Johnsonville Cafeteria / Environmental Health walk-thru 3/16/23

Sill under
raceway
@ Service
window

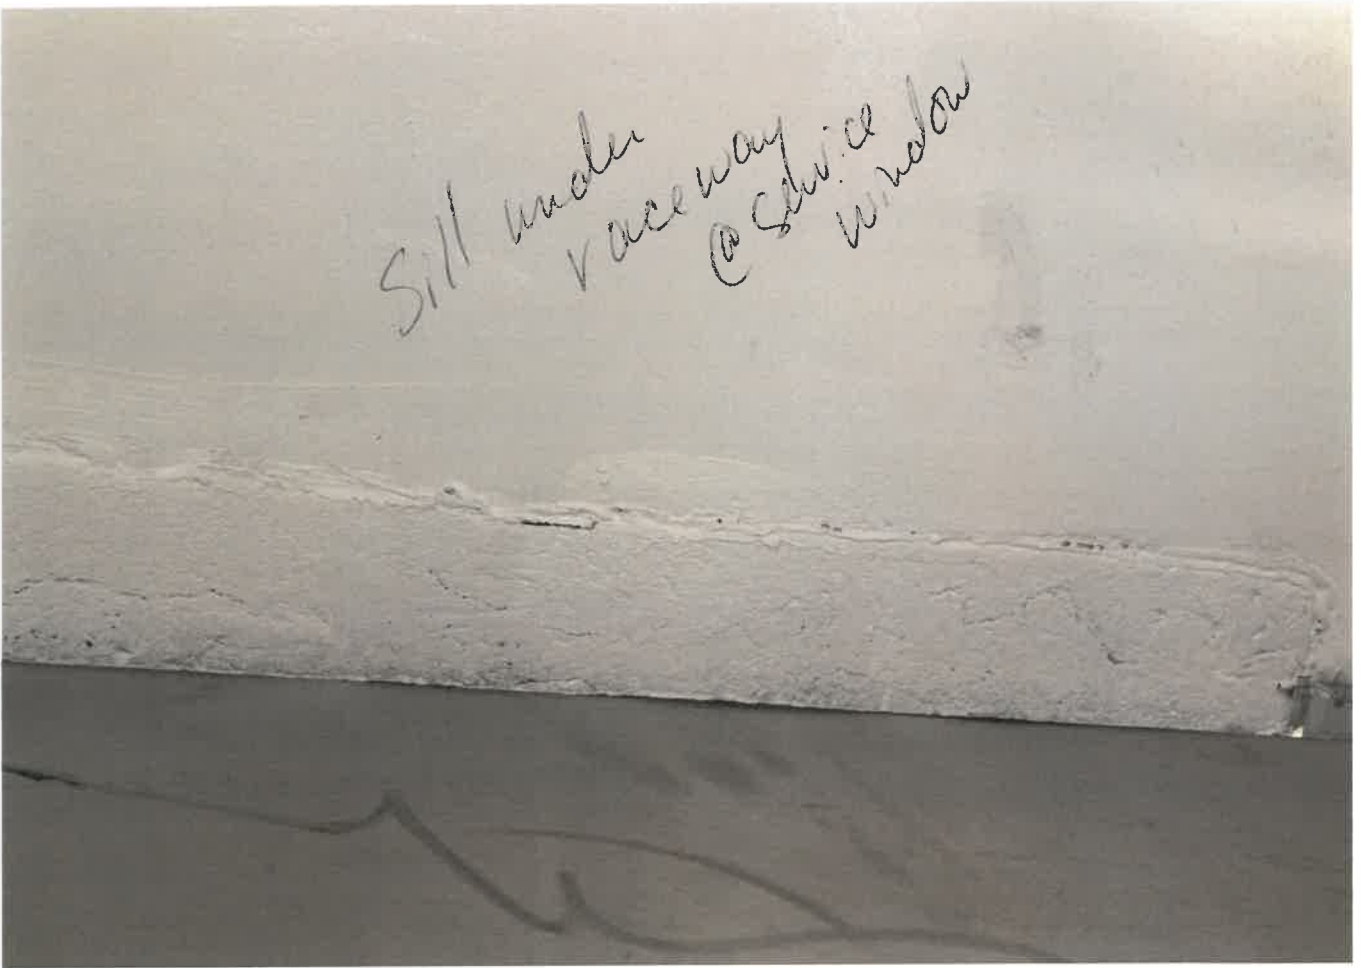
- Rough wall seams
- Areas of shallow grout
- Rough wall finishes especially near frame out of doorway leading to ice machine area
- Sill block under raceway at service window very rough with cracks and gaps across width
- Caulk missing or not smooth and intact at 3 comp backsplash and wall juncture
- Wall/paint damage under 3 comp at water supply piping
- Wall mount shelf support bracket missing
- Water piping under pre-rinse not flanged
- Wall rough/damaged and unfinished at water piping under pre-rinse
- Metal trims at dish machine exhaust to ceiling junctures not seated correctly
- No soap dispenser at handsink
- No hand drying provision at handsink

Custodial

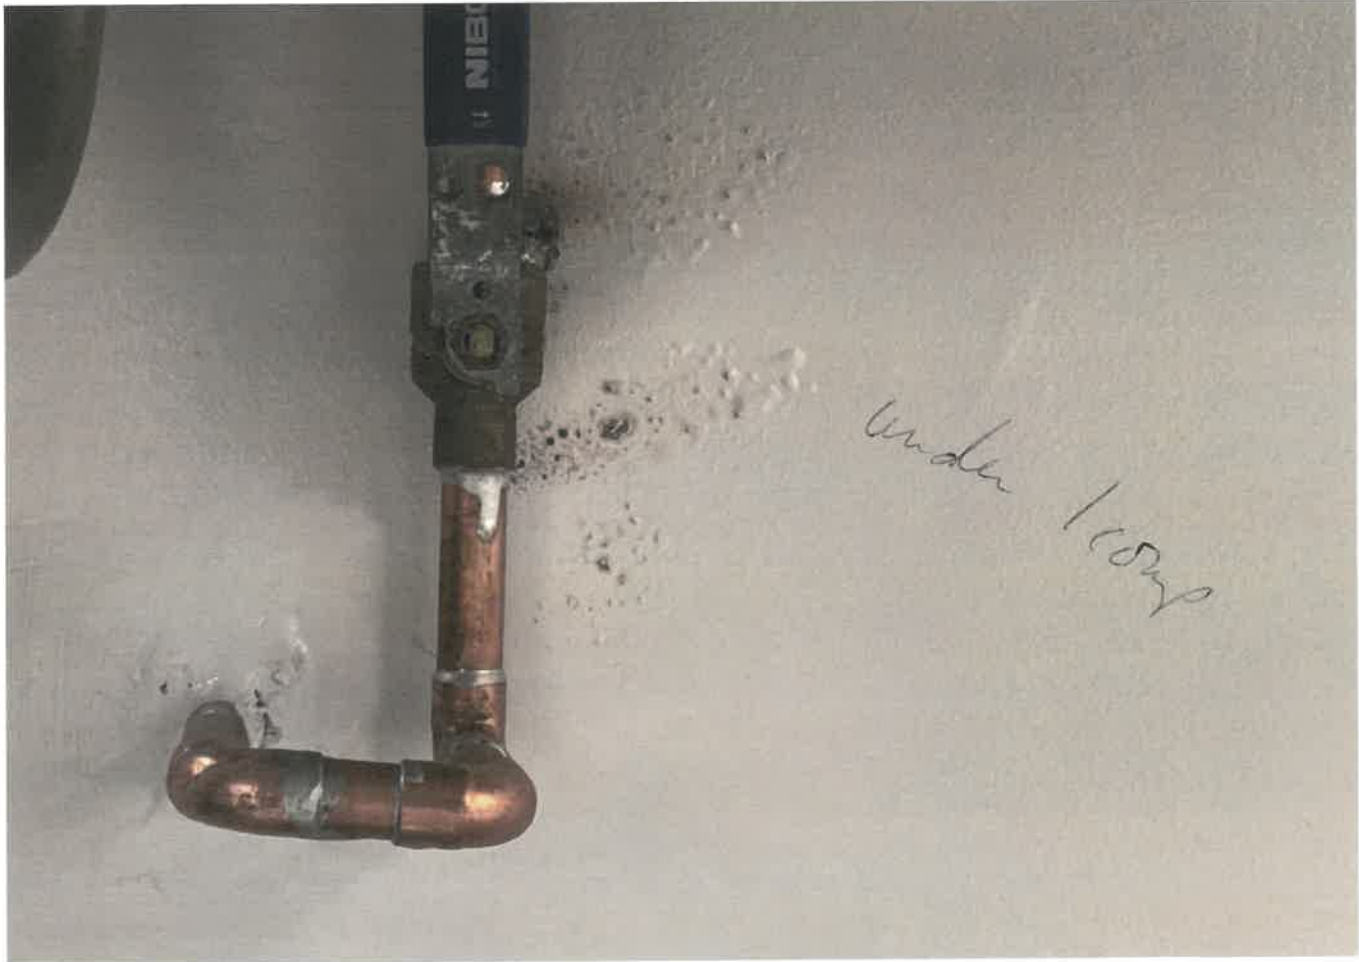
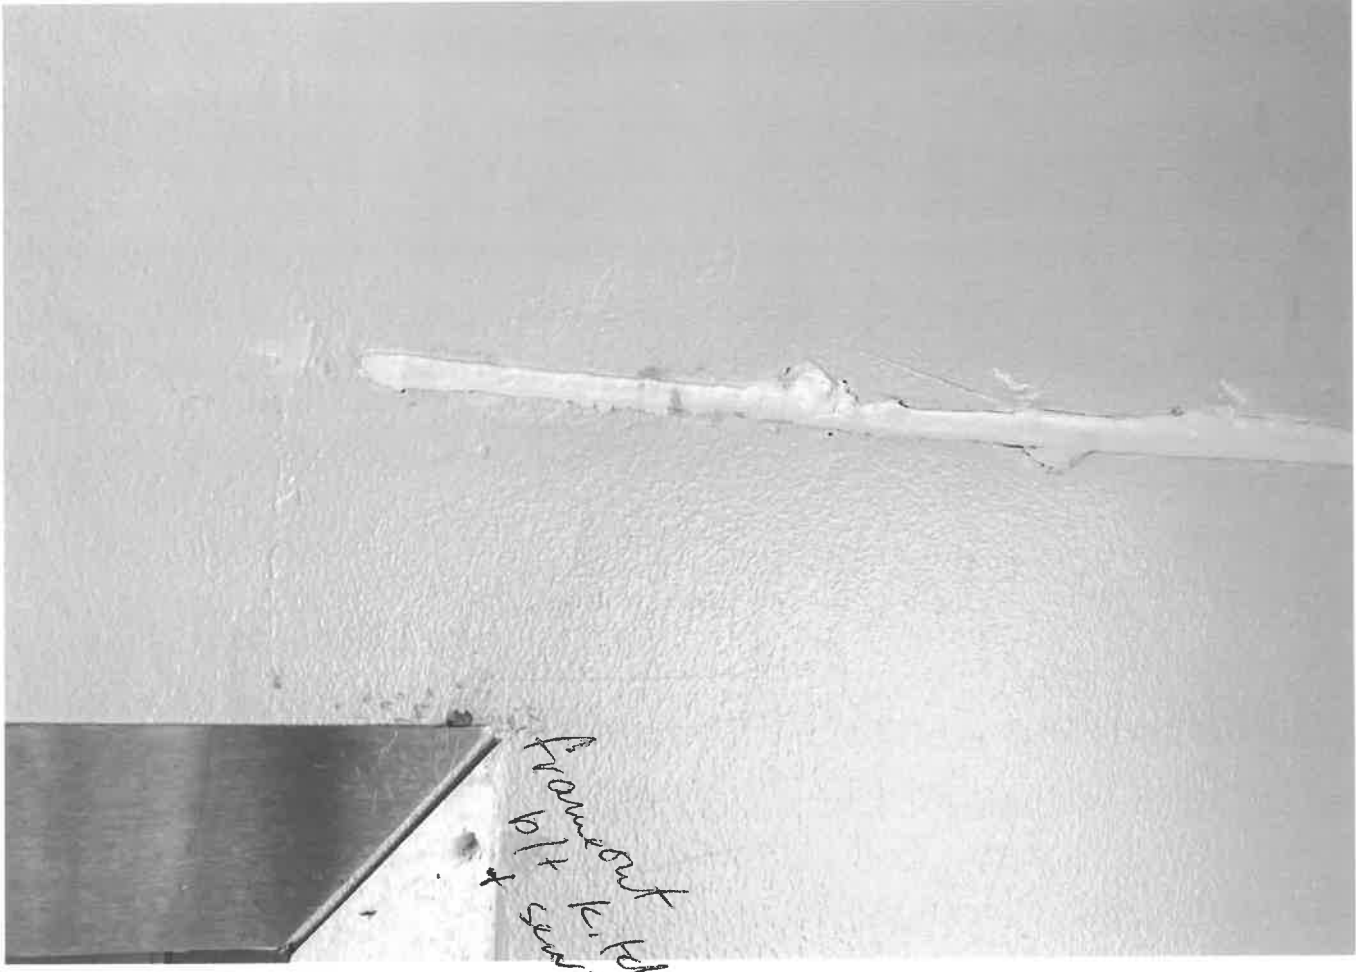
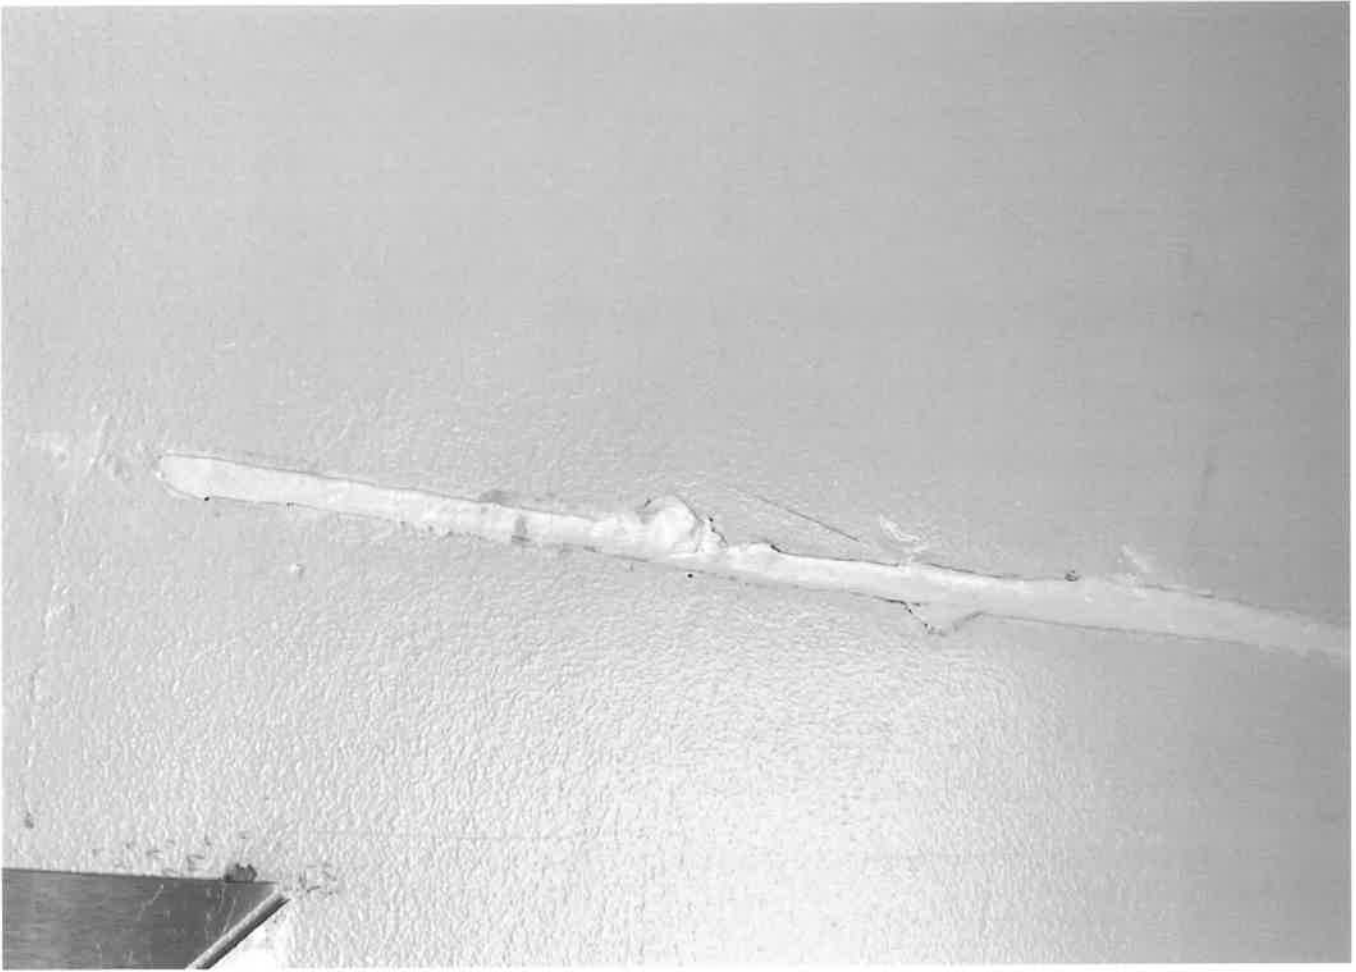
- Rough finishes at base to wall juncture especially behind door
- Rough wall finishes in multiple areas including behind door and at hose bib

foot plates tilt Skillet/ Steamers

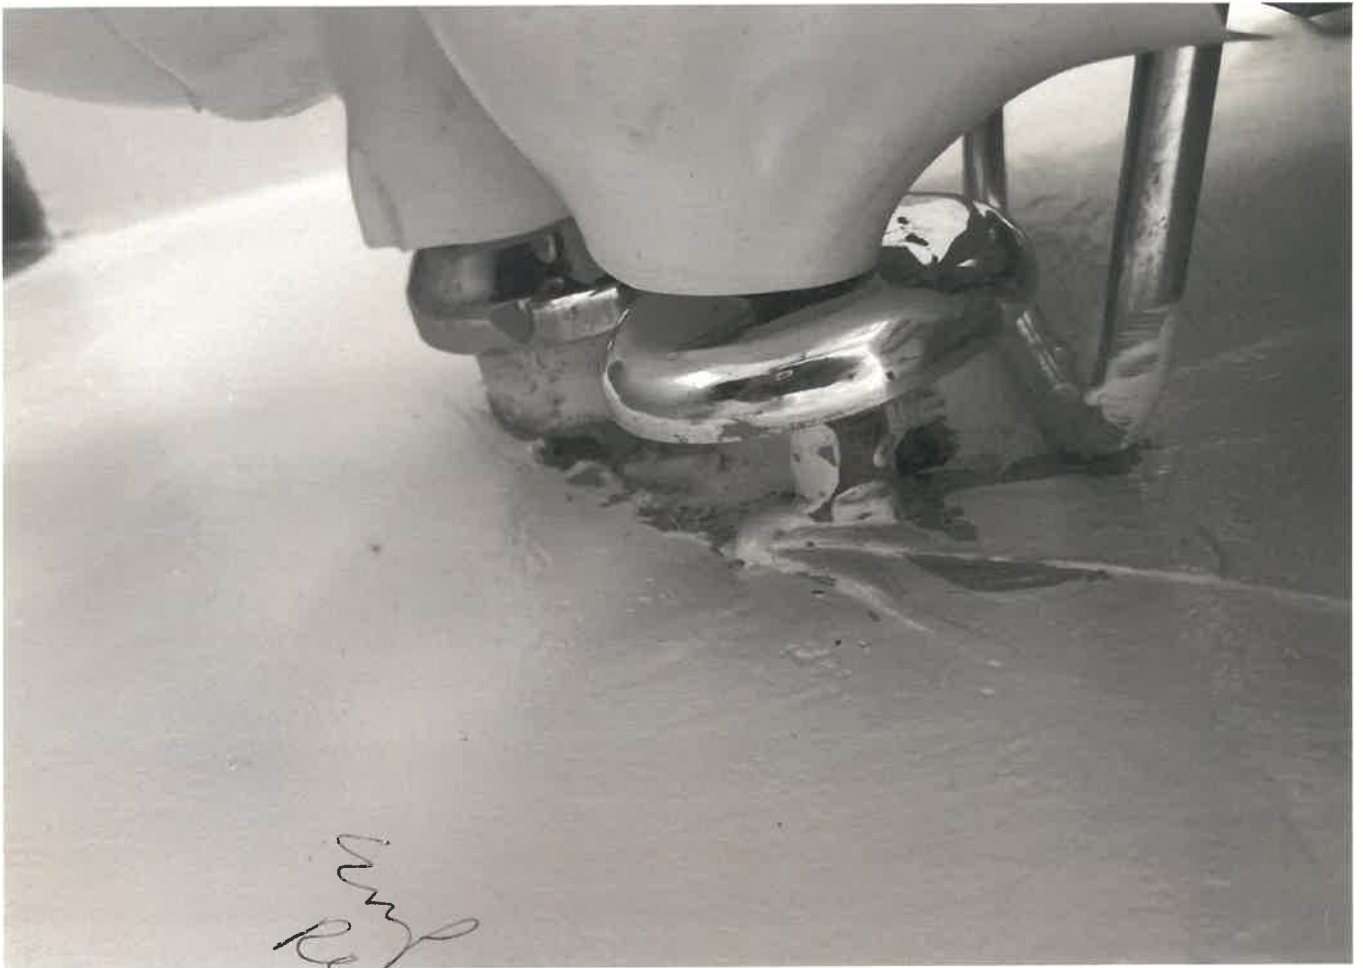
- Rough, poorly filled wall seams
- Metal frame out trim pieces at pass thru holding equipment not tight
- Foot plates on tilt skillet and steamers have recessed areas, damaged screw heads

Outlet
Conduits

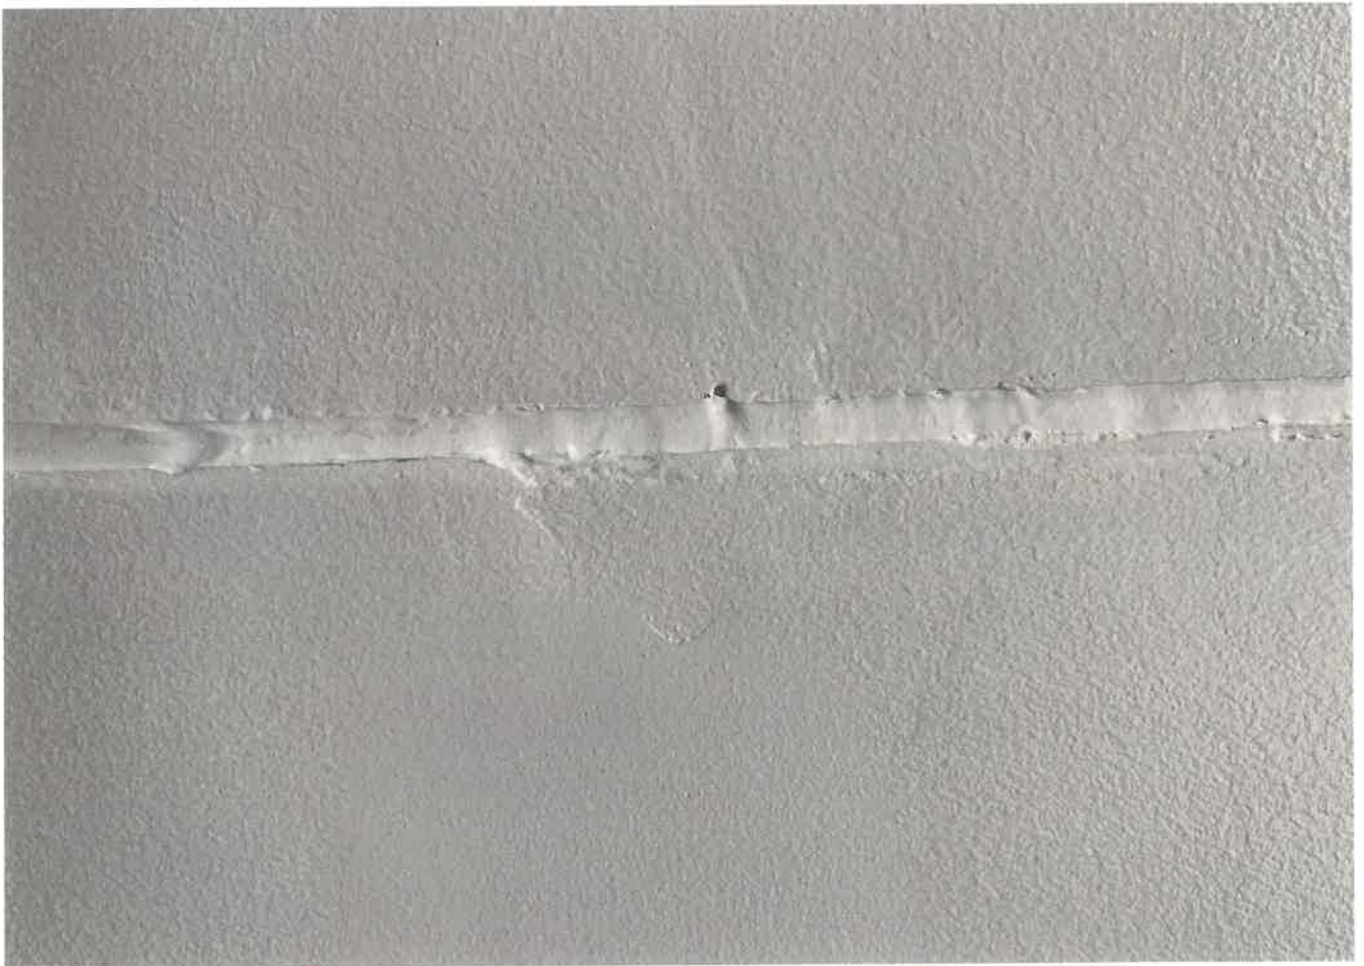
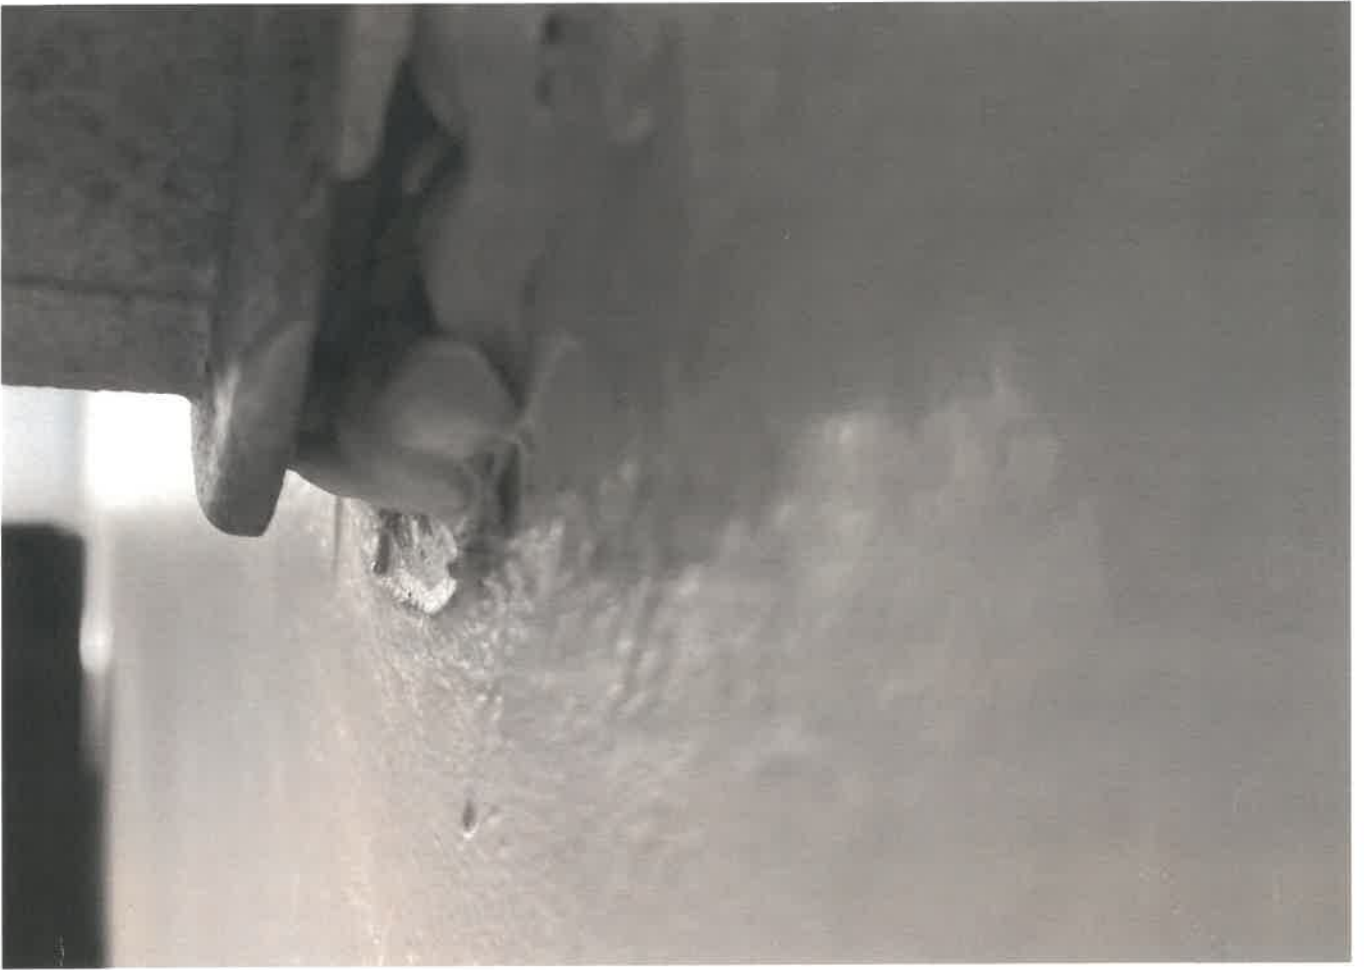
- Multiple steamers dented or otherwise damaged
- Area around conduits servicing floor outlets in multiple areas recessed or built up and rough
- Open and rough juncture at walk-in freezer and wall.
